DSX Access Systems, Inc.

1040PDP Power Distribution Module

New - 1040PDM Rev 10 Regulated Lock Power

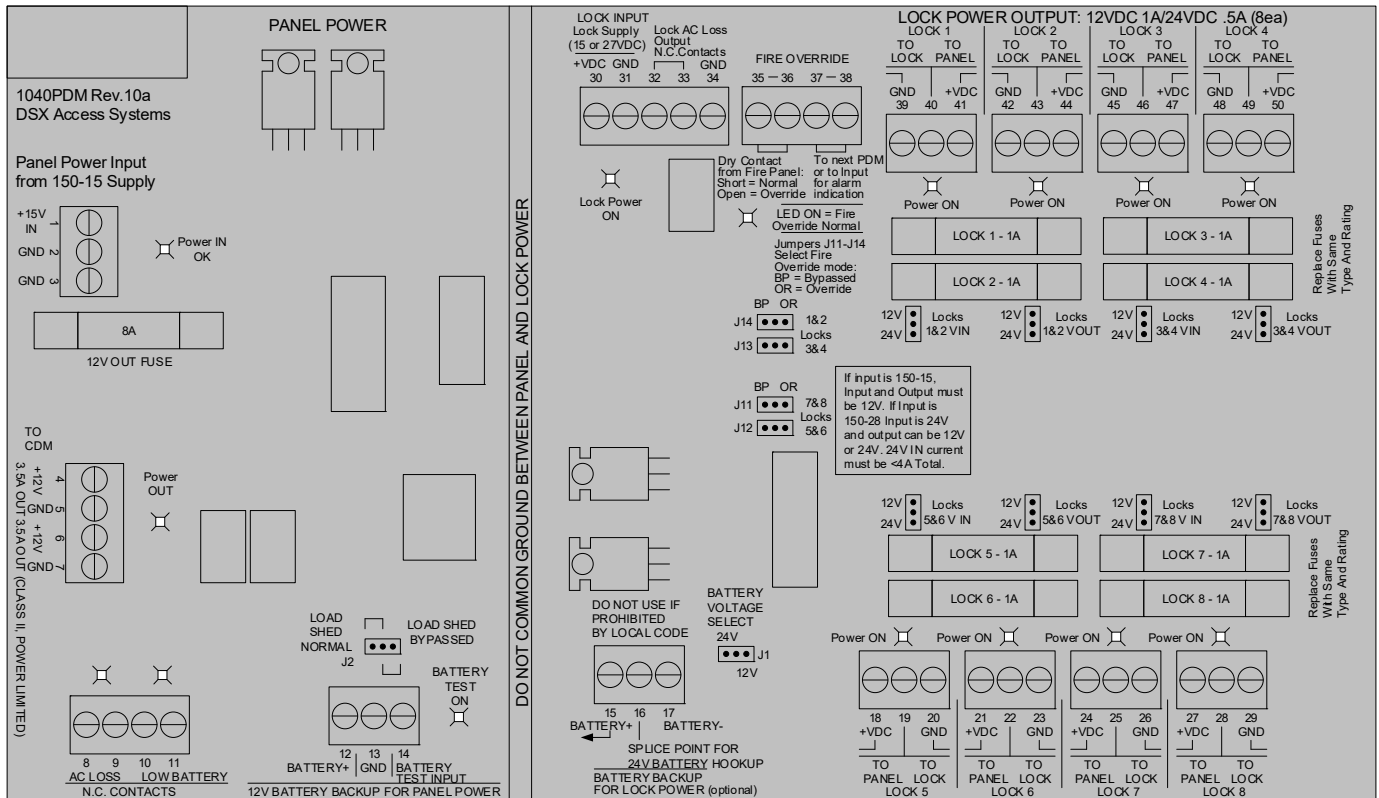
This new Power Distribution Module has several new enhancements.

- Regulated Lock Power so the Output Voltage is either 12 or 24 Volts while the Battery Charging Circuit is high enough to charge either 12 or 24V Batteries.
- Each Two Lock Outputs can be set for 12 or 24 Volts In and Out.
- Each Two Lock Outputs can be set for Fire Override or to Bypass Fire Override.
